UNITED STATES PATENT AND TRADEMARK OFFICE

10/582,222

Office Action Summary	Application No. 10/582,222	Applicant(s) OHMA, ATSUSHI	
	Examiner STEPHEN YANCHUK	Art Unit 1795

DETAILED ACTION

Fig. 4A

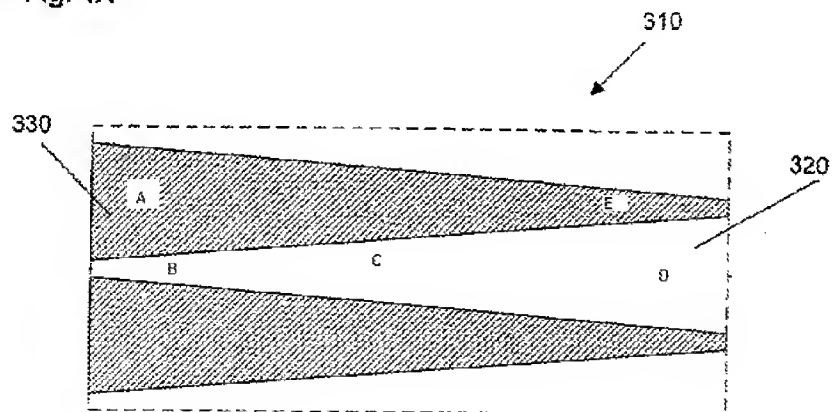
1. All outstanding objections and rejections are withdrawn in light of applicant's amendment filed on 2/03/2010
2. The text of those sections of Title 35, U.S. Code not included in this action can be found in prior office action.
3. The new grounds of rejection set forth below are necessitated by applicant's amendment filed on 2/03/2010. The following action is properly made final.
4. The 112 rejection is overcome by amendment.
5. Although the 112 rejection is overcome by amendment, the way in which the claim is written able to be broadly interpreted. The various regions shown by "A-E" are possible regions that can be used to define "1st region" and "2nd Region".

Claim 11: The instant claim is to a separator comprising ribs wherein it is commonly known that separator is also defined as a bi-polar plate or a plate between the electrode-membrane-electrode assembly and the ribs are entities forming a gas or fluid flow channel. Upon inspection of the specification, the claim to temperature variation is due to non-uniformities in the gas flow path and coolant channels, wherein Knight teaches such limitations. One specific example is temperature dependency based on sectional area.

Knight teaches an electrochemical fuel cell having reactant flow passages with non-uniform design to increase reactant access to adjacent fluid distribution layer at the outlet region as compared to the inlet region [Abstract]. Knight teaches a fuel cell comprising: A membrane with electrodes on opposite sides [Paragraph 4], the plurality of cells [Description, Figure 3], at least a first region and second region wherein temperatures of the first region are higher due to change of channel structure of the flow field [Figure 4-6]. The gas diffusion is improved by the embodiments of figure 4-6, specifically figure 4 wherein the reactant flow passage widens [Paragraph 32]. It can be interpreted that each region can be higher in temperature or lower in temperature than any other region. The structure of the system goes through start up, steady state, and shut down. During Start up: section B is hotter than C hotter than D; Steady state: Section D may be hotter than C hotter than B. Sections A and E are inherently going to be lower temperature than the B-D

Claim 12: 1st region is element C and 2nd region is element B or D.

Claim 13: Knights teaches coolant flow channels that mirror the reactant flow passages [Paragraph 14, 34-39]. If region 1 is C then element B or D as the 2nd element reject this claim based on where the inlet of the coolant is, with or against the flow of the fuel.

Claim 14: This claim compared element C of a middle fuel cell with the same element C of an outer cell. It is an inherent property that the middle will have a higher temperature during operation due to heat sources being on both sides of it whereas the end portions will only have 1.

Claim 15: 1st section is element C and 2nd section is element B wherein B is smaller in sectional area than C

Claim 16: The 1st section has not been defined structurally and is therefore open to interpretation, Sections B, C, D widen toward outlet and are lower in temperature than sections A and E as well as each other.

Claim 17: Section 1 being C or D has section B or C, respectively, where section 1 has smaller ribs wherein the ribs are the area that gas does not flow.

Claim 18: The width of the rib, around element E decreases from a 1st region of element C.
